PALISADES PLANT

AMENDMENT TO PROVISIONAL OPERATING LICENSE

Amendment No. 24
License No. DPR-20

ATTACHMENT TO LICENSE AMENDMENT NO. 24

FIGURE 6.2-1

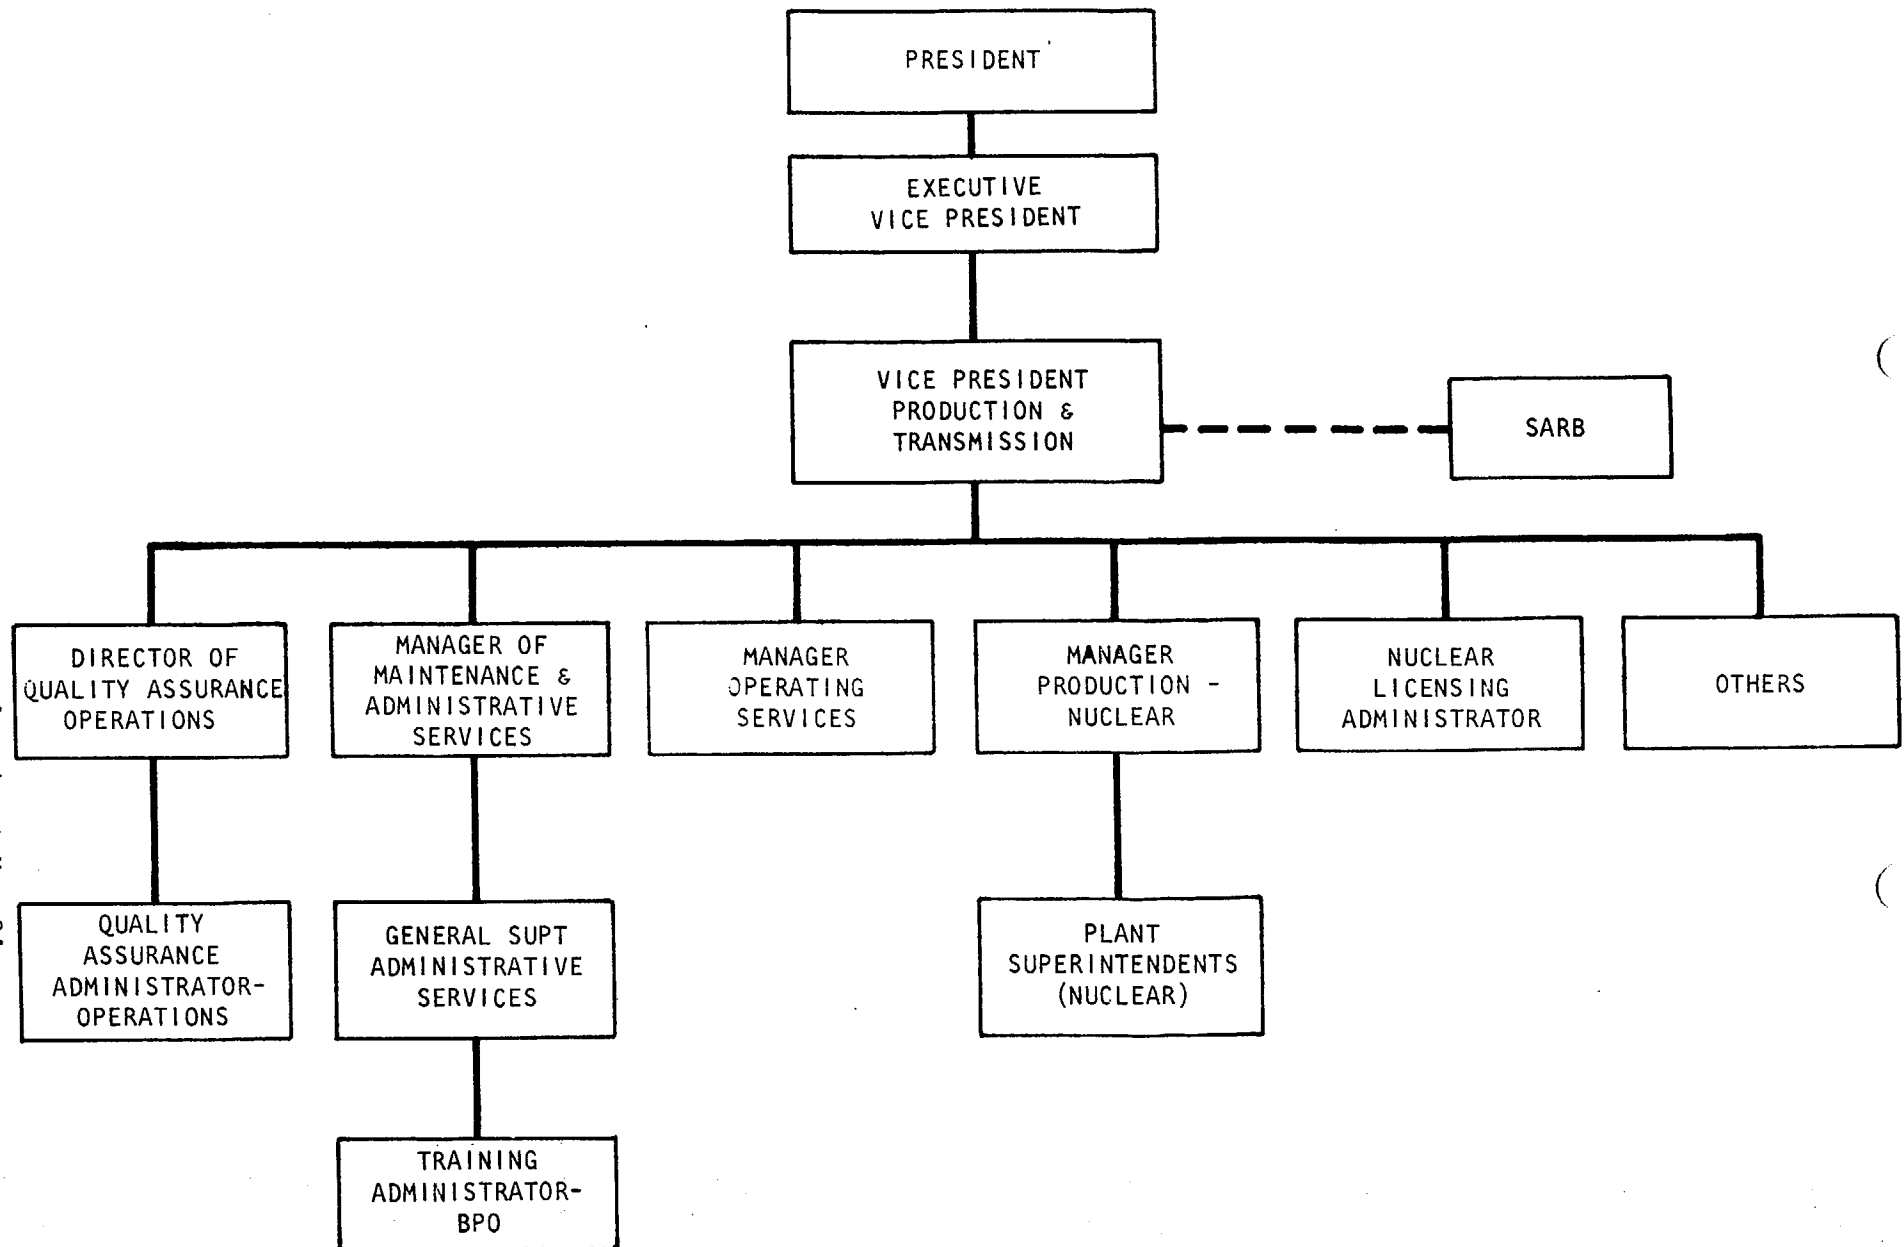
This amendment makes revisions to the Off-Site Organization and other applicable areas of the Administrative and Controls Section of the Technical Specifications to reflect organizational changes within your company.

The present Palisades Technical Specifications reflect an Off-Site organizational structure in which the Safety and Audit Review Board (SARB) is responsible to the Executive Manager - Bulk Power Operations. A recent reorganization within Consumers Power Company resulted in the elimination of certain positions and others which were retitled. As a result of this reorganization, the SARB now reports to the Vice President-Production and Transmission. The proposed amendment would change applicable portions of the Administrative Controls Section of the Palisades Technical Specifications.
